September 15, 2022

**Re: Aurora One Master Plan: PA 1 - Commercial (#1655056)/Pre-Application Meeting held September 01, 2022**

**Re: Aurora One Master Plan: PA 1- Commercial (#1655056)/Pre-Application Meeting held September 1, 2022**

**1D. Master Plan – Aurora One**

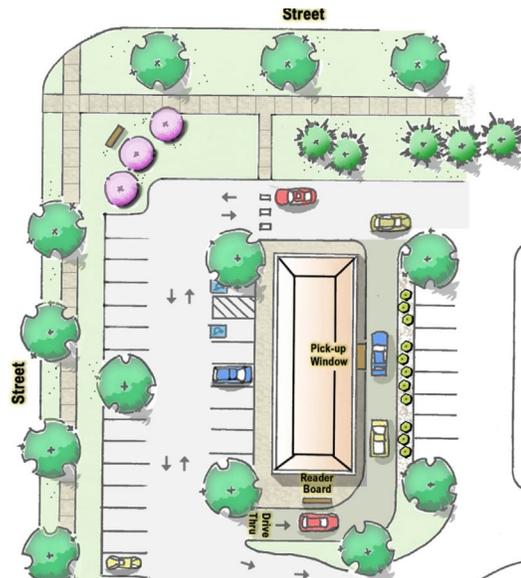
PA-1 of the master plan is designated as a commercial use parcel within the Hogan Crossings planning area. Per the master plan, “*Hogan Crossings is first-class, regional, convenience-oriented hub serving local regional users who live within Aurora One or who are accessing the development through Picadilly Road.*” Additional guiding principles for this planning area can be found on Sheet 6 (page 279) of the recorded Master Plan.

Per the master plan, the above drawing is meant to be an illustrative graphic, and “is not intended to reflect the final condition of any neighborhood, area or specific site”. Additionally, when

NO STRUCTURES PROPOSED AT THIS TIME. FUTURE ISPs WILL CONFORM TO MASTER PLAN AND UDO

**3D. Access and Connectivity**

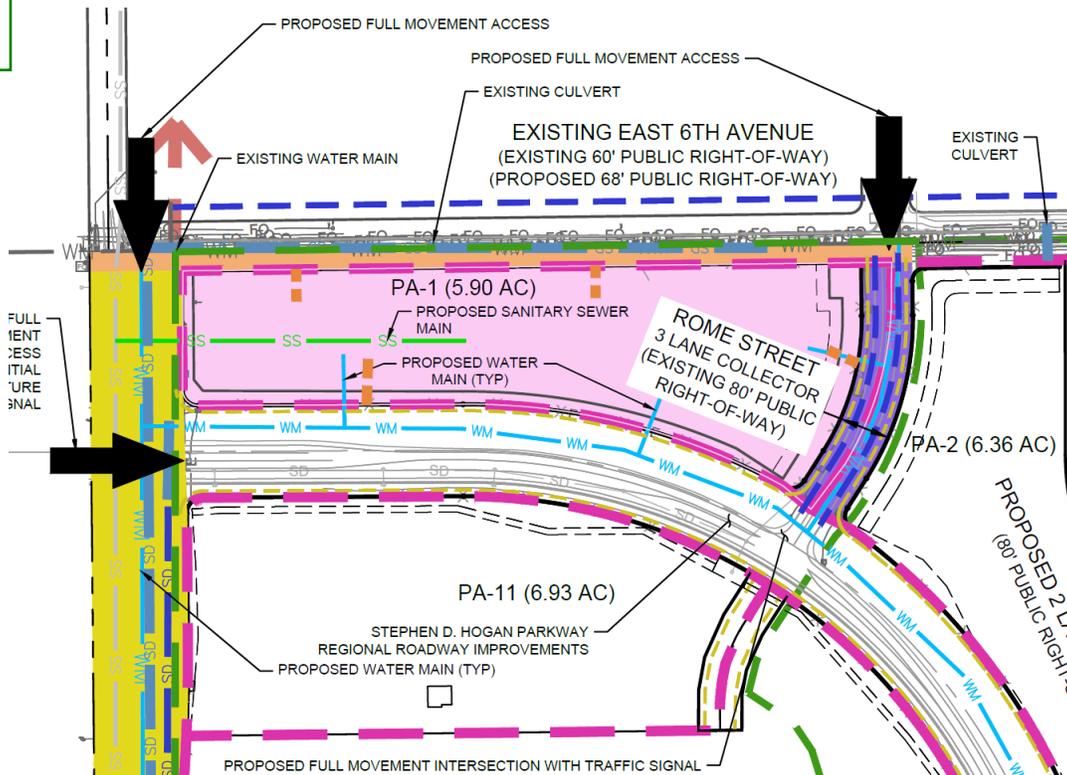
Access points on the proposed plan align with those demonstrated in the PIP within the Aurora One Master Plan (image below for reference). Abutting and surrounding street, trail and sidewalk improvements for Picadilly, 6<sup>th</sup>, Stephen D. Hogan, and Rome should be completed with site plan development. Section details for the streets and pedestrian paths as well as streetscape design standards are located on sheets 13-16 (pages 312-321).

NOTED. THIS ISP SHALL PROPOSE ACCESS POINTS (DRIVEWAY CUTS) IN CONFORMANCE WITH THE MASTER PLAN. NO INTERIOR ACCESS/CONNECTIVITY PROPOSED AT THIS TIME. FUTURE ISPs SHALL CONFORM TO REQUESTED ACCESS/CONNECTIVITY

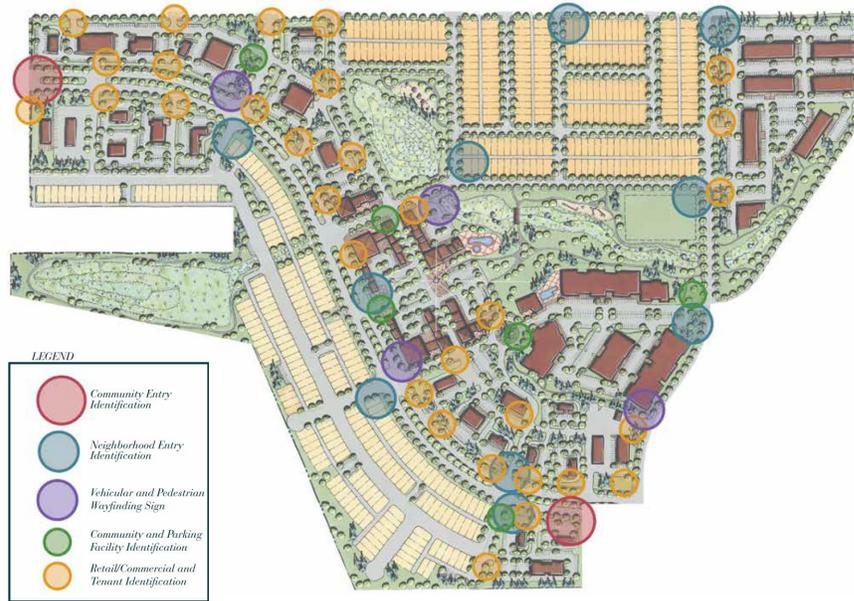
Section 146-4.10 of the UDO governs signage standards. Master plan standards for signs are located on sheets 9 and 10 (pages 291-298). The master plan has identified locations for universal tenant signage which should be used for each pad site. Individual monuments for each user are discouraged. A community entry identification sign is planned at the intersection of Stephen D. Hogan and Picadilly. Please review this section for complete details.

NO SIGNAGE PROPOSED AT THIS TIME. FUTURE ISPs WILL BE IN ACCORDANCE WITH UDO

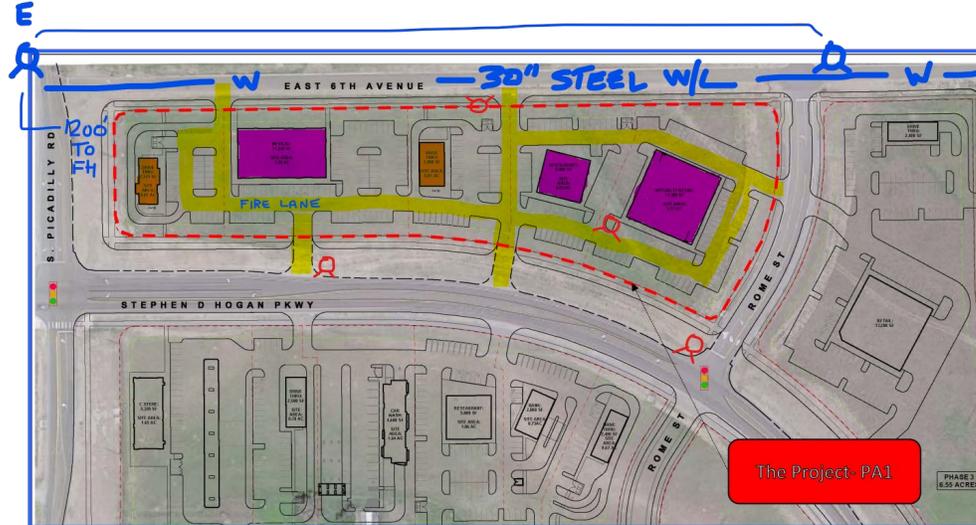
- **Fire Lane Easement**
  - Buildings less than 30' in height require only a 23' wide fire lane easement with 29' inside and 52' outside turning radii. Building greater than 30' in height require a 26' wide fire lane easement with a 26' inside and 49' outside turning radii.
  - Buildings greater than 30' in height are regulated by the 2015/2021IFC Section D105 and require a both a 26' Fire Lane Easement and two points of emergency access. Typically, the 26' fire lane easement is located on the front main entry side of the structure within a minimum of 15' and a maximum of 30' from the exterior wall of the building. Structures greater than 30' in height also require a second point of emergency access.

NOTED. NO STRUCTURES OR INTERNAL ROADWAYS PROPOSED AT THIS TIME
